# UNITED STATES PATENT AND TRADEMARK OFFICE

APPLICATION NO.	FILING DATE	FIRST NAMED INVENTOR	ATTORNEY DOCKET NO.	CONFIRMATION NO.
10/684,491	10/15/2003	Alec G. Dodd	84702/3032 Gnn	8877
20736	7590	04/20/2005	EXAMINER	
MANELLI DENISON & SELTER 2000 M STREET NW SUITE 700 WASHINGTON, DC 20036-3307				LE, TAN
ART UNIT		PAPER NUMBER		
		3632

<b>Office Action Summary</b>	Application No.	Applicant(s)	
	10/684,491	DODD ET AL.	
	Examiner Tan Le	Art Unit 3632

**DETAILED ACTION**

FIG. 3

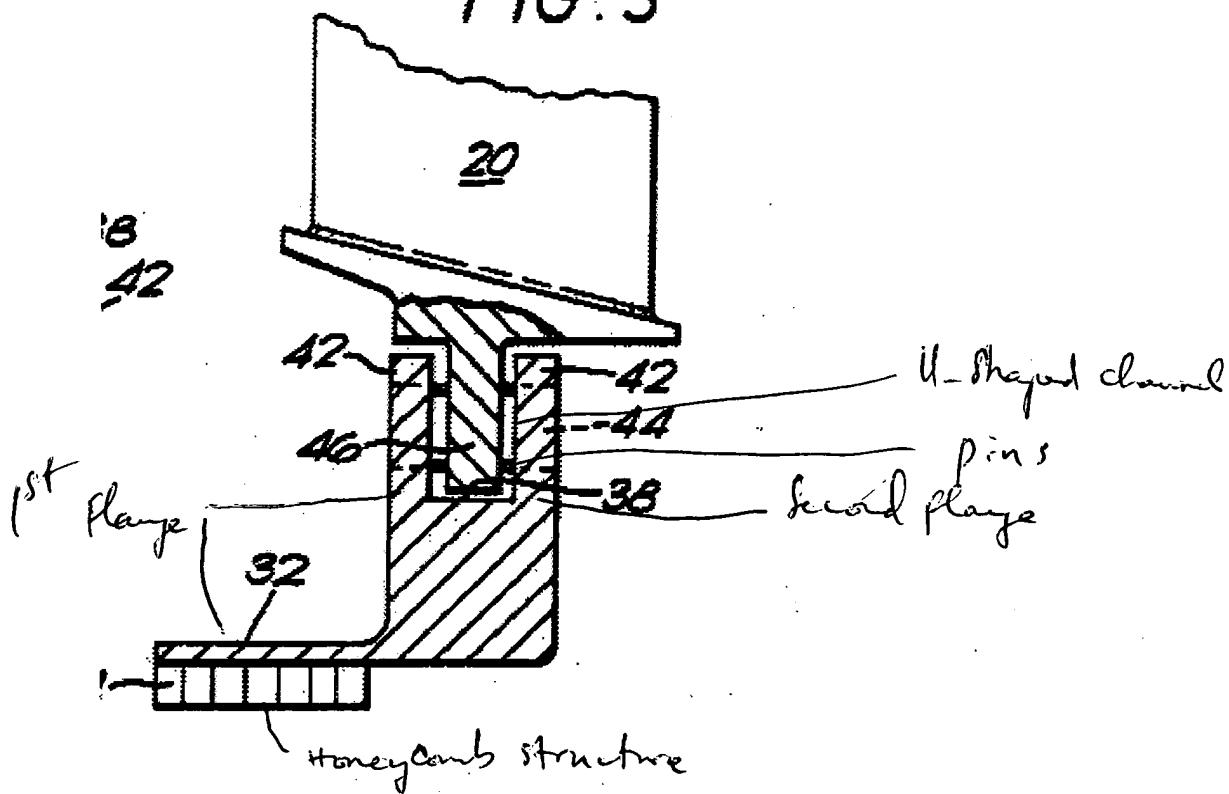
As to claim 1, Hirst teaches a labyrinth seal outer portion which carries an abradable lining (34) and at least two radially, separately formed, outwardly extending members defining first and second flanges (see marked-up copy), at least one of said members being adapted to support said internal abradable lining, the flanges being adapted and shaped to cooperate with one another so as to form channel therebetween (38) and said channel being shaped so as to receive one or more connecting members extending radially inwardly from inner ends (46) of a plurality of stator vanes.

As to claim 2, Hirst also teaches the first member flange comprising an axially extending portion supporting said abradable lining and a radially outwardly extending portion fixed radially outwardly extending portion of said second member wherein at least said first member formed such that radially extending U-shaped channel being formed radially outwardly from a region of connection of said members.

As to claim 3, Hirst also appears to teach the members each comprises a convoluted pressed sheet.

As to claim 5, Hirst also teaches a number of angularly spaced pairs of pins (44) and being fixed by their ends in the channel and the pins being spaced from one another by a distance which enable an insertion therebetween of an inwardly directed feature on the inner ends of a plurality of stator vanes associated therewith.

As to claim 8, Hirst also teaches the abradable lining being a honeycomb structure.
